Re: Kettle Park West Traffic Impact Analysis Update Review

We have completed a review of the Kettle Park West (KPW) Traffic Impact Analysis Update (TIAU) completed by JSD Professional Services, Inc. (JSD) dated February 29, 2016. After an initial review of the TIAU, we asked for clarification on several aspects of the study. JSD subsequently provided a revised TIAU on March 30, 2016. This letter summarizes our review of the revised TIAU and our recommendations.

To: Rodney Scheel, City of Stoughton
From: Bill Dunlop, JSD
Re: Traffic Impact Analysis - Update
JSD Project #: 15-7018
Date: 12 April 2016
cc: Jeff Held, Mark Fisher, Strand; Dennis Steinkraus, FDG; Dave Jenkins, Adam Watkins; JSD; Jeff Fait, TADI

Figure 1 Site Plan and Study Intersections

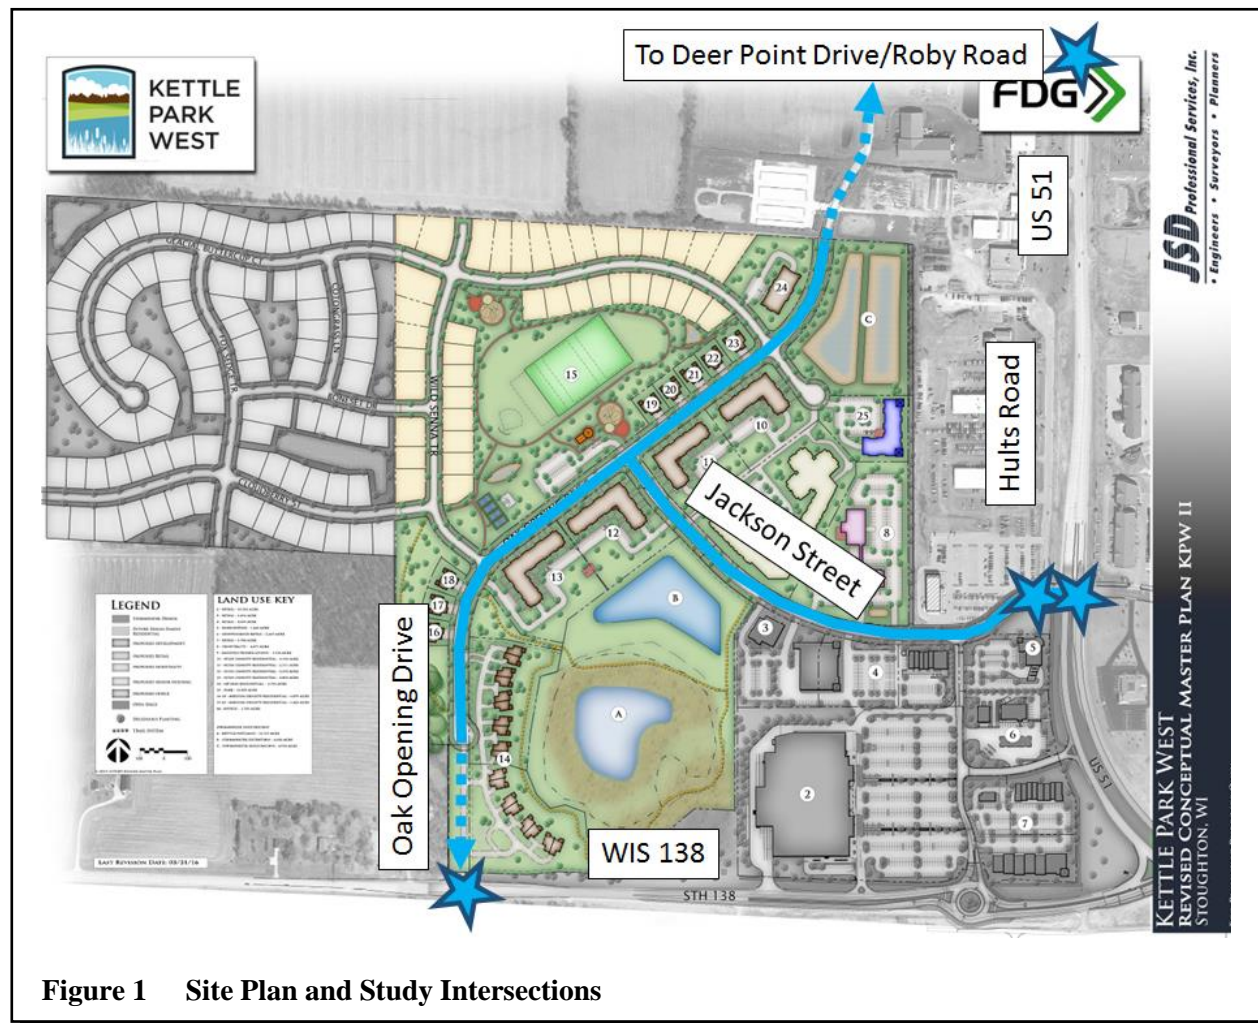
The revised TIAU evaluates the following three conditions:

Condition 1: No KPW connection to US 51 at Deer Point Drive/Roby Road, no KPW connection to WIS 138 at Oak Opening Drive.

Condition 2: KPW connection to US 51 at Deer Point Drive/Roby Road (under both stop-control and traffic signal-control), no KPW connection to WIS 138 at Oak Opening Drive.

Condition 3: KPW connection to US 51 at Deer Point Drive/Roby Road (under traffic signal-control) and KPW connection to WIS 138 at Oak Opening Drive.

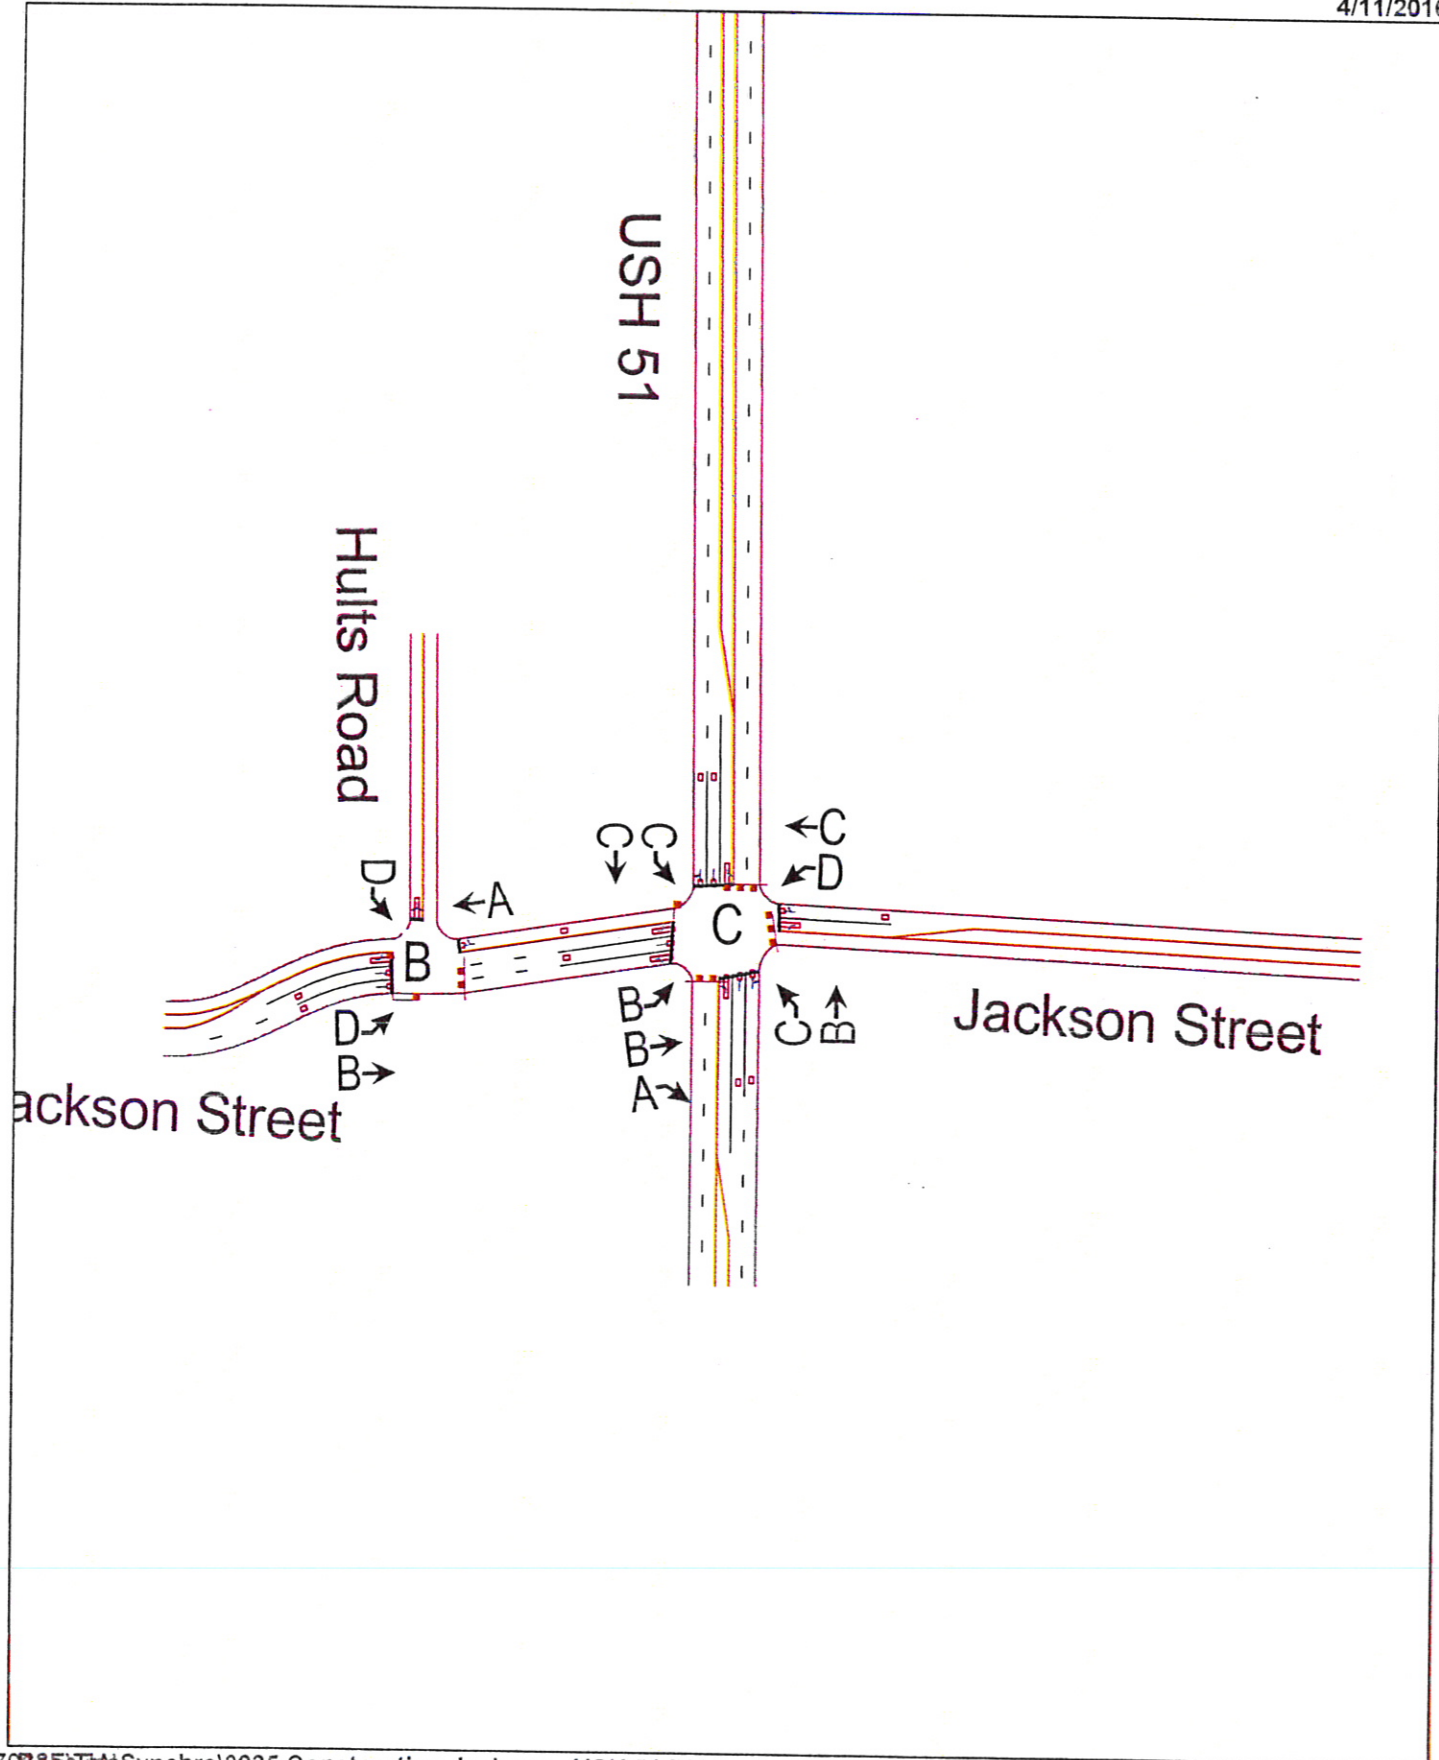
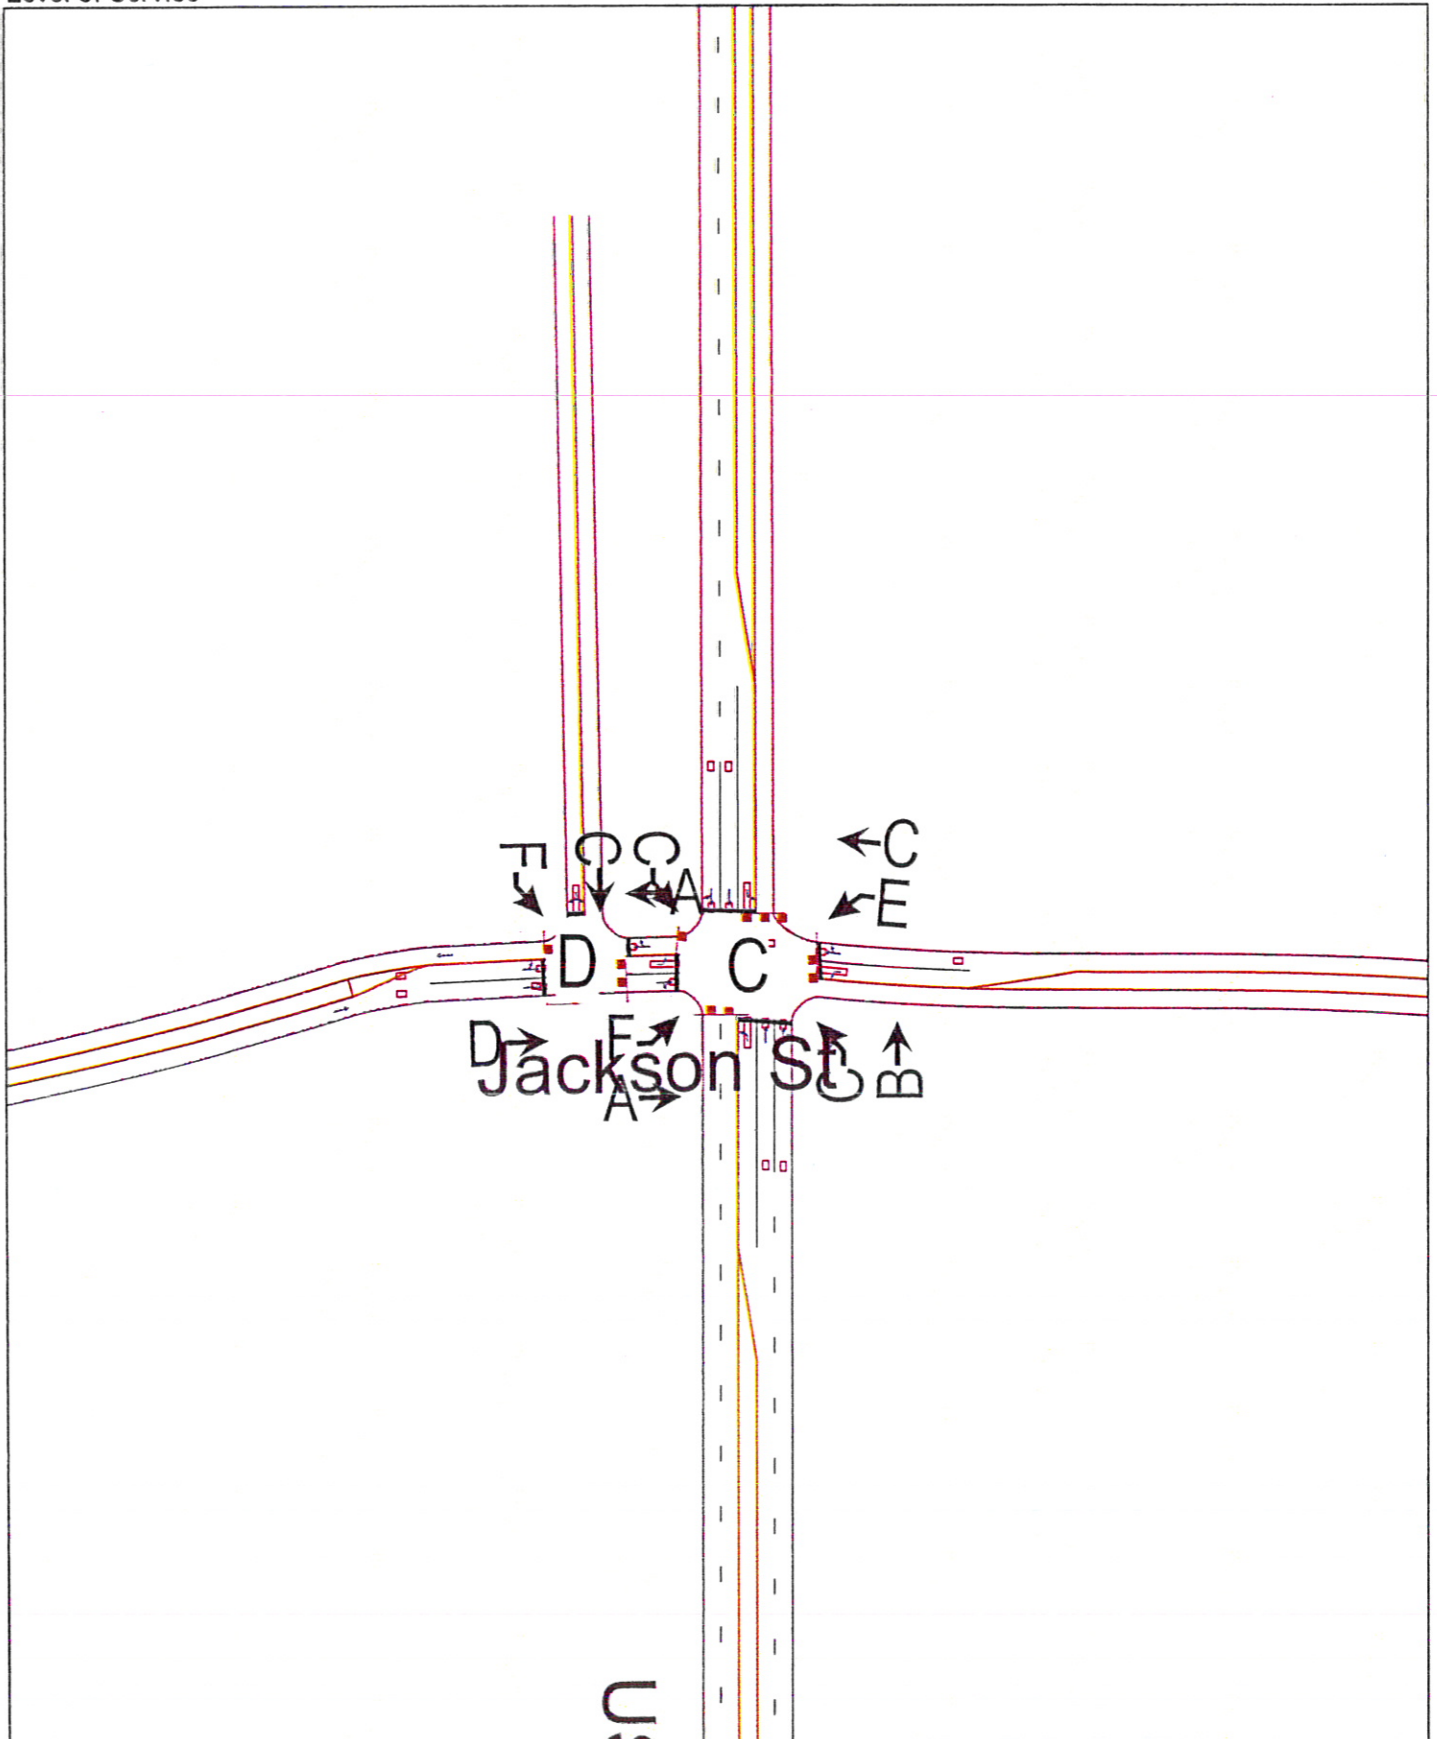
1. Trip Generation – No comments or response.
2. Trip Distribution and Assignment - No comments or response.
3. Traffic Modeling Results –
 - a. We requested the model used by the reviewer to compare methodology. The model provided to the reviewer did not reflect the approved lane configuration for the west leg of Jackson Street at the intersection with USH 51/Hults Road. The west leg modeled in the TIA – Update had a left turn lane, a thru lane and a right turn lane. This matches the attached plan sheets approved by the City and DOT and which has been constructed. The model provided to the reviewer had two lanes, a thru-left land and a right turn lane.

The difference in the model would most likely account for difference in level of service (LOS) between the two analyses at the Jackson Street intersection in the 2035 analysis.

- b. As stated in the review, we did optimize the signal timing in the model which resulted in the lagging left versus the leading left. In our discussion with the reviewer, this signal timing is not typically used but can be used where required. Our analysis is provided as a reasonable assurance to the City and DOT that the intersection will function through 2035 at required levels. Ultimately, the DOT will operate the signal at the intersection of Jackson Street and USH51/Hults Road and set the signal timing based on field observations and performance of the signals once they are in place, as the reviewer stated.
